**TOWN OF PLYMOUTH
PLYMOUTH MUNICIPAL AIRPORT**

CONSTRUCT, MARK, AND LIGHT TAXIWAY 'E' EXTENSION (APPROX. 500' X 35')

ADDENDUM No. 3

Date: December 22, 2020

L1.1

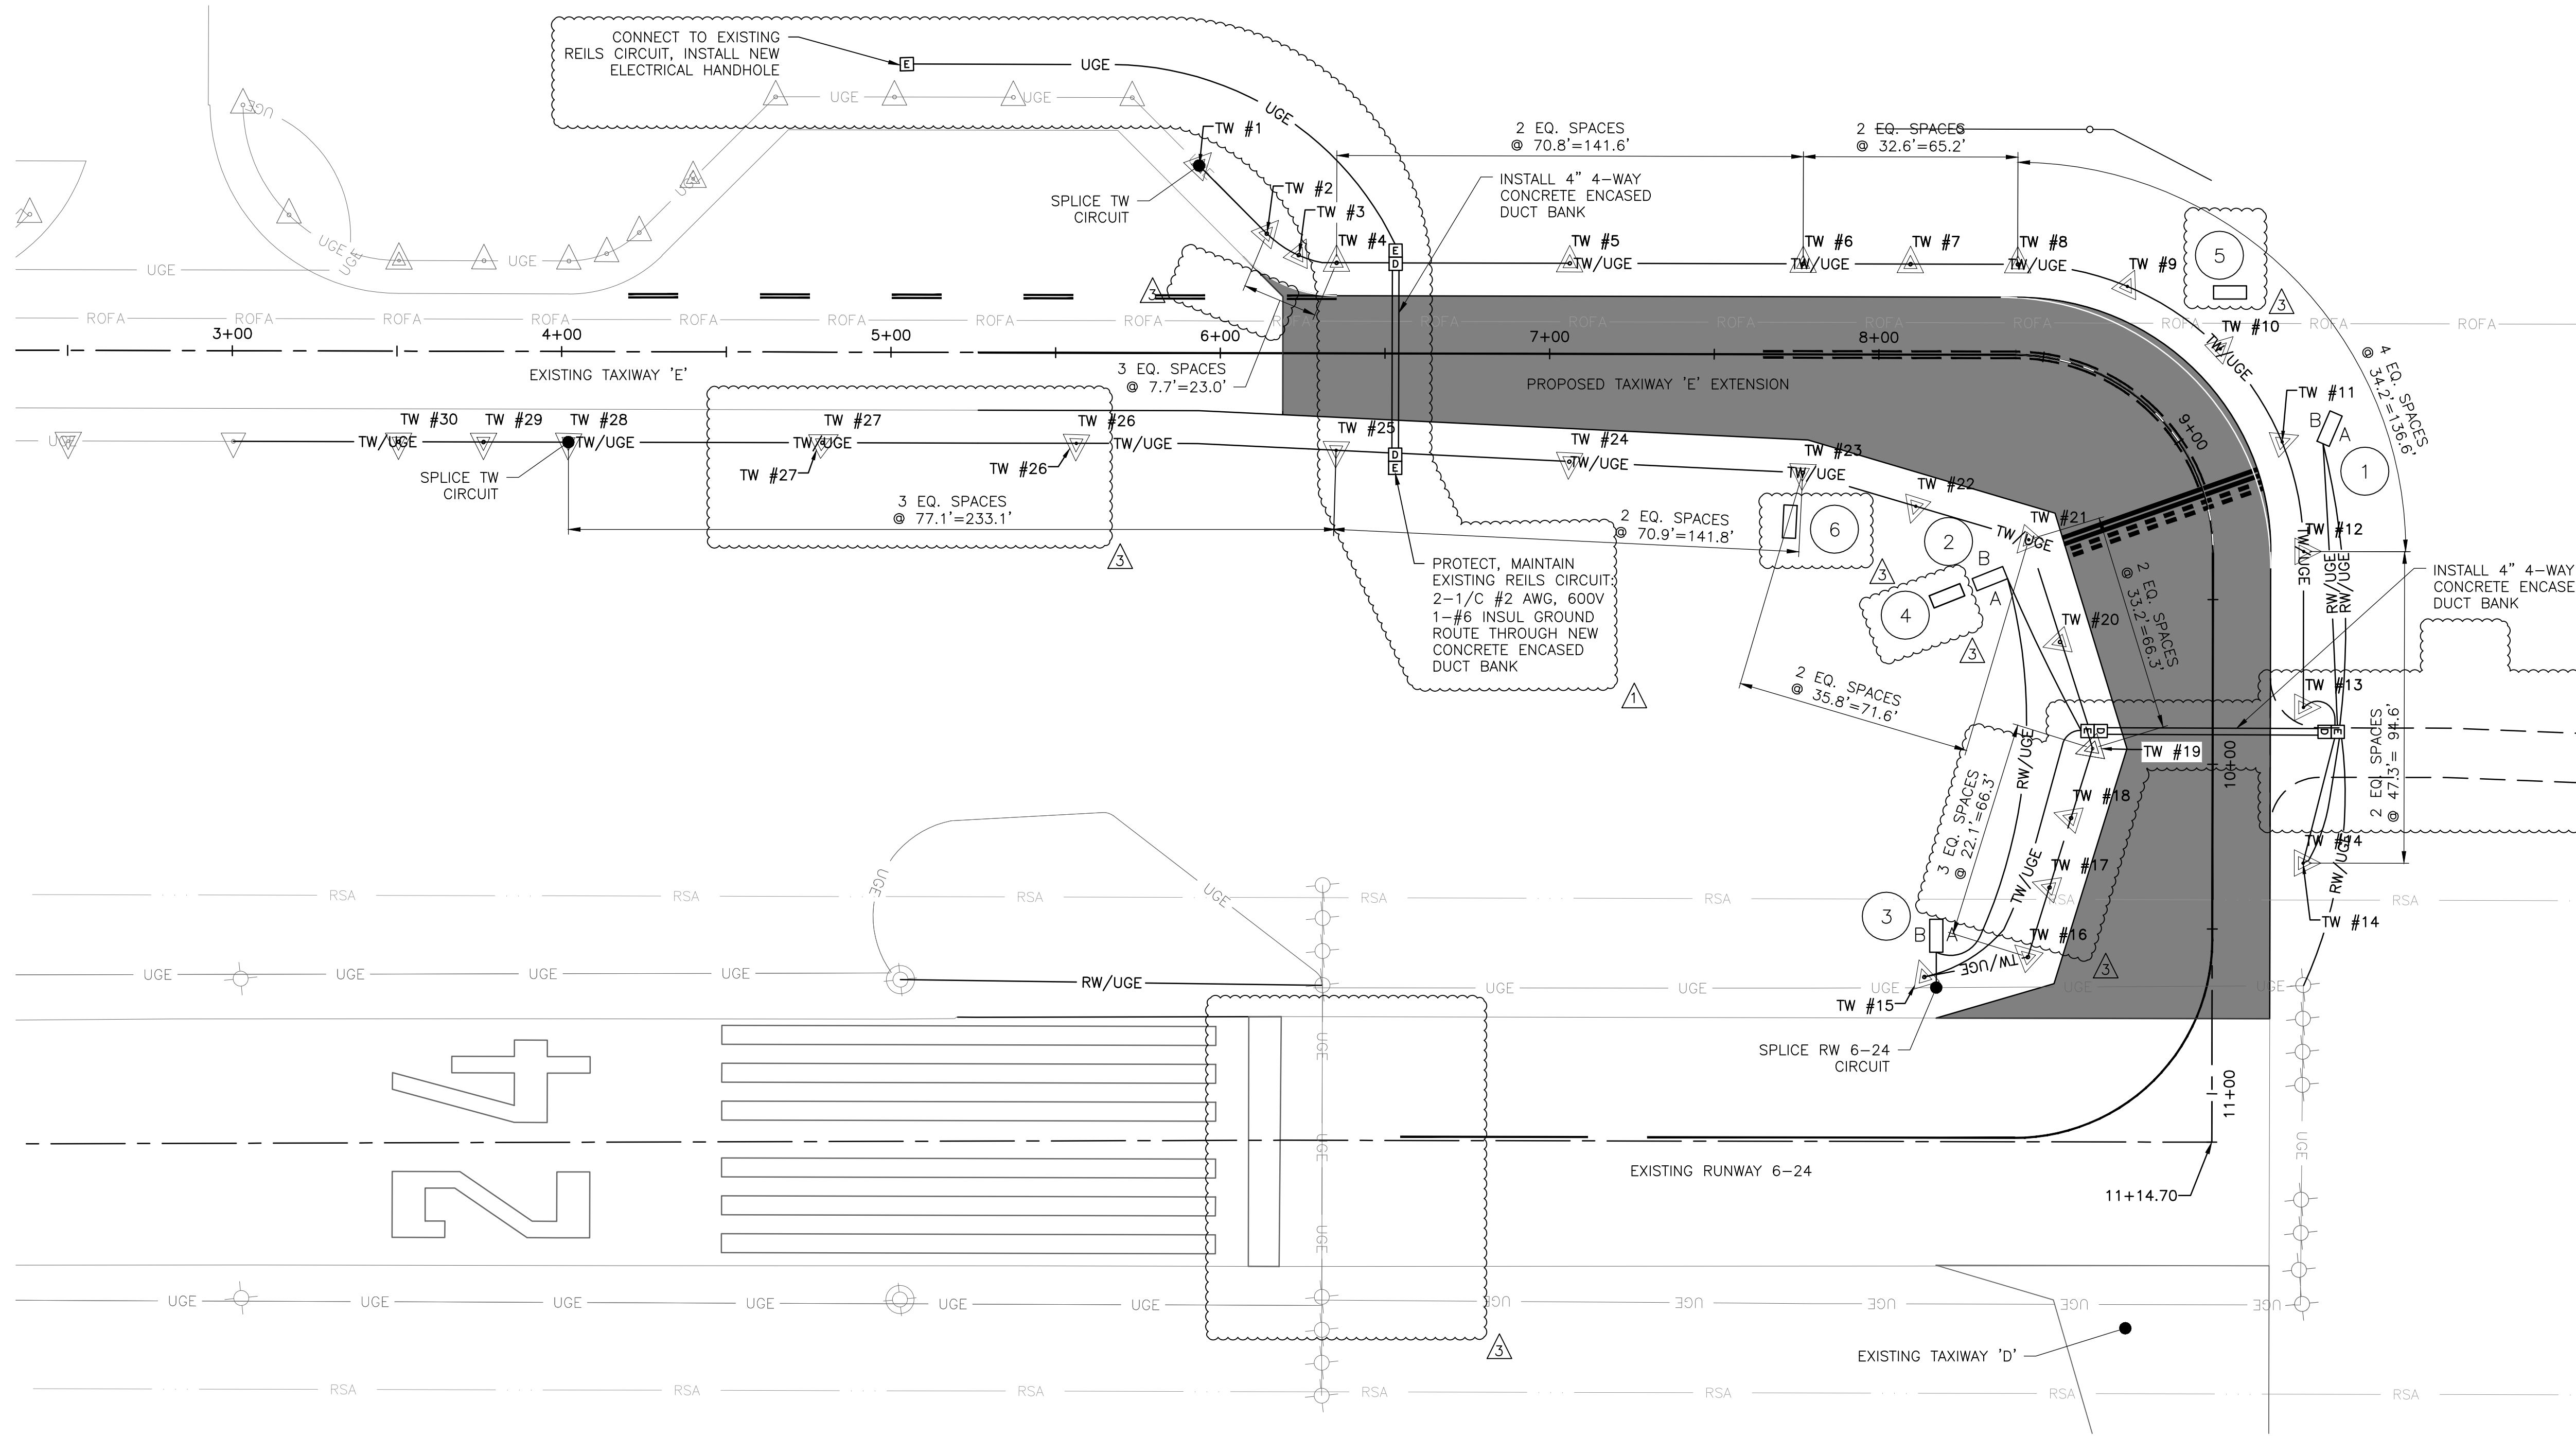
11. Drawing C3.1 has been revised to clarify the limits of proposed pavement, which now excludes the haul road.
12. Drawing L1.1 has been revised to modify two light spacing areas which results in the addition of two base mounted taxiway edge lights. Additionally, one guidance sign and one foundation for an additional guidance sign has been added. Also, the Duct Bank under the haul route has been removed.

L2.2

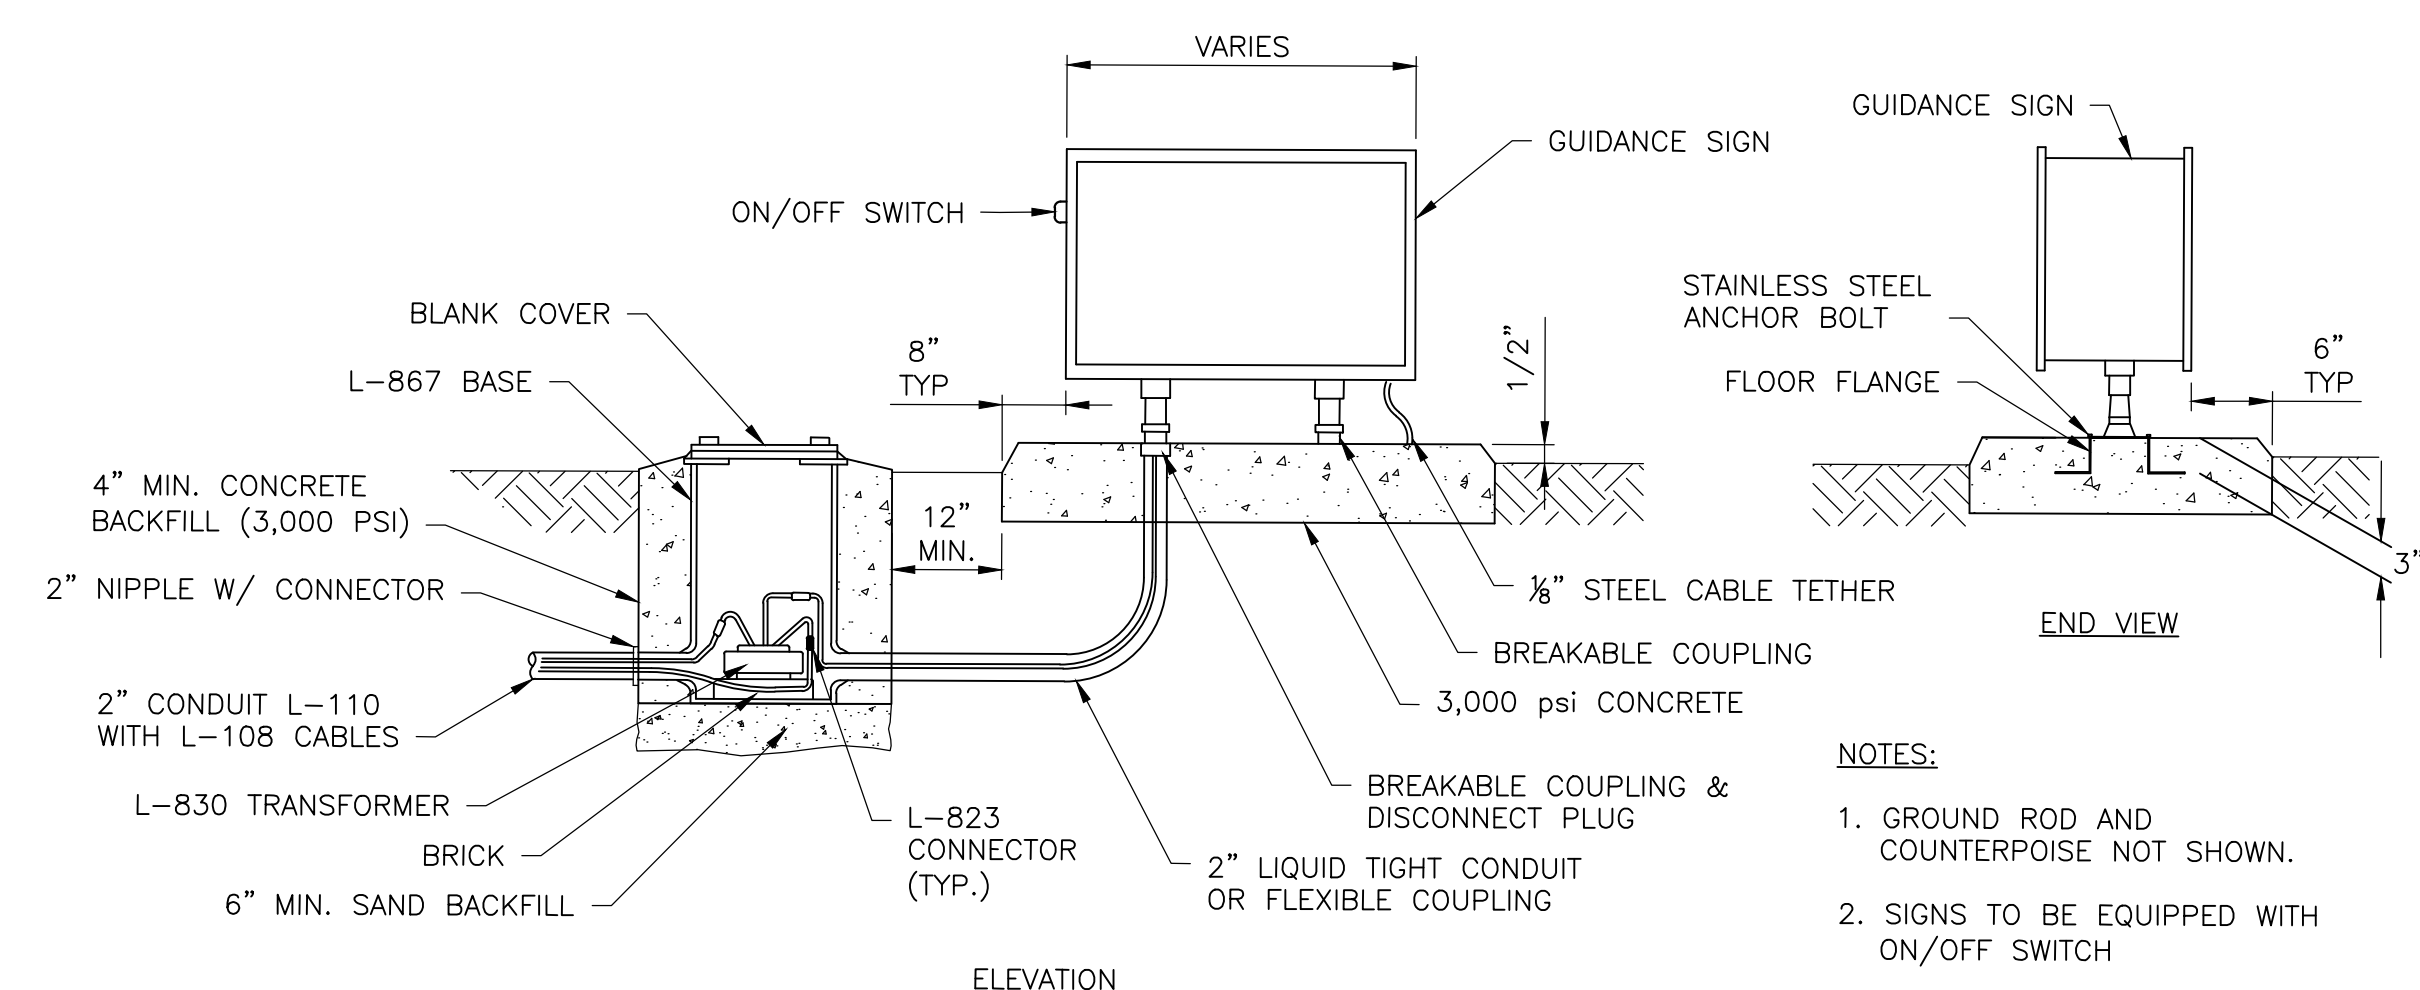
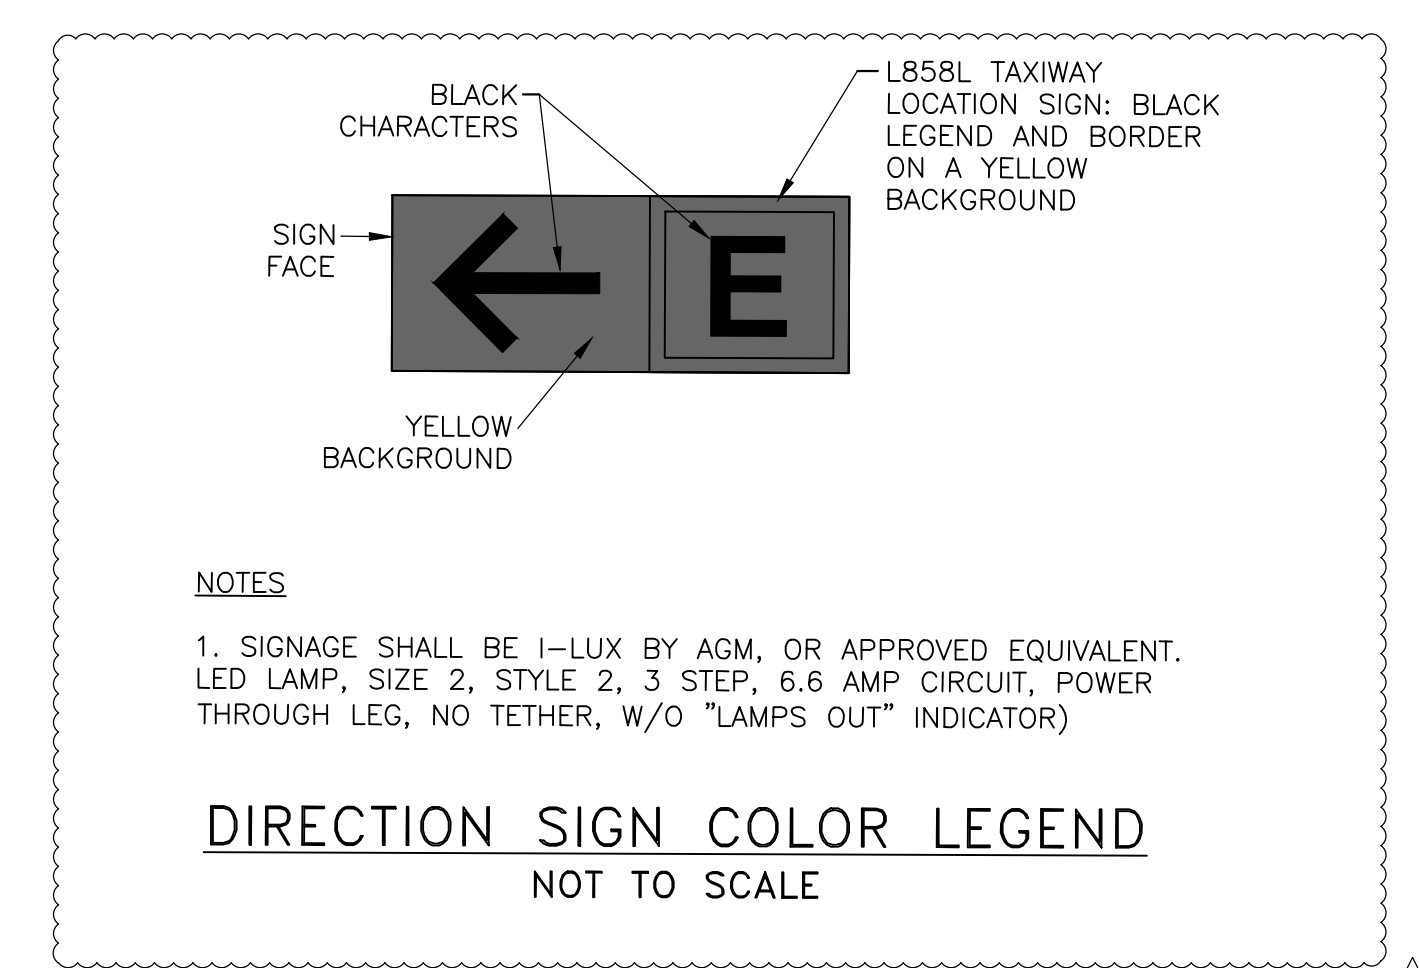
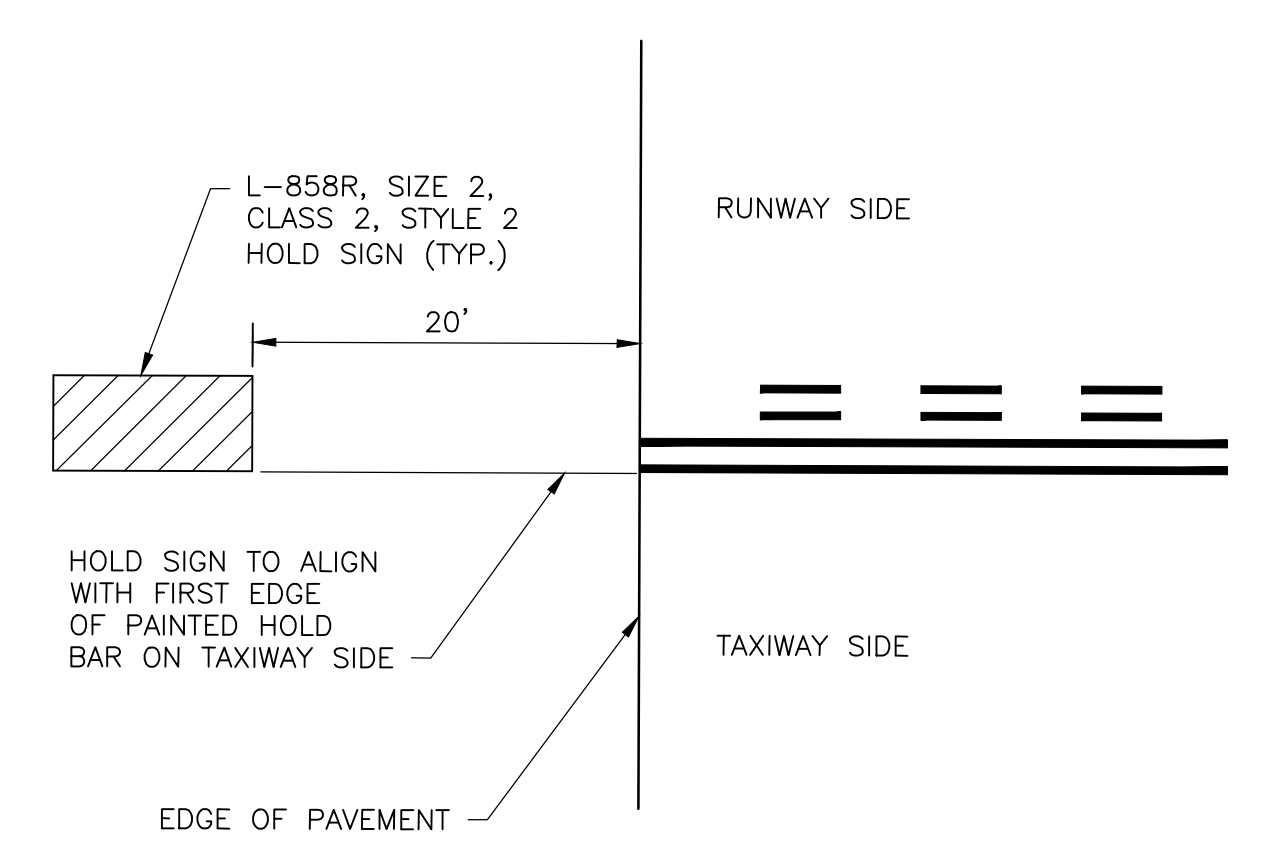
13. Drawing L2.2 has been revised to show the revised sign schedule, and remove the vehicle service road metal sign, which has been removed from the project.
14. Drawing M1.1 has been revised to show the new taxiway edge markings and modified centerline striping at the runup apron.
15. Drawing M2.1 has been revised to show the new taxiway edge marking detail for the runup apron, and remove the ILS hold line marking.
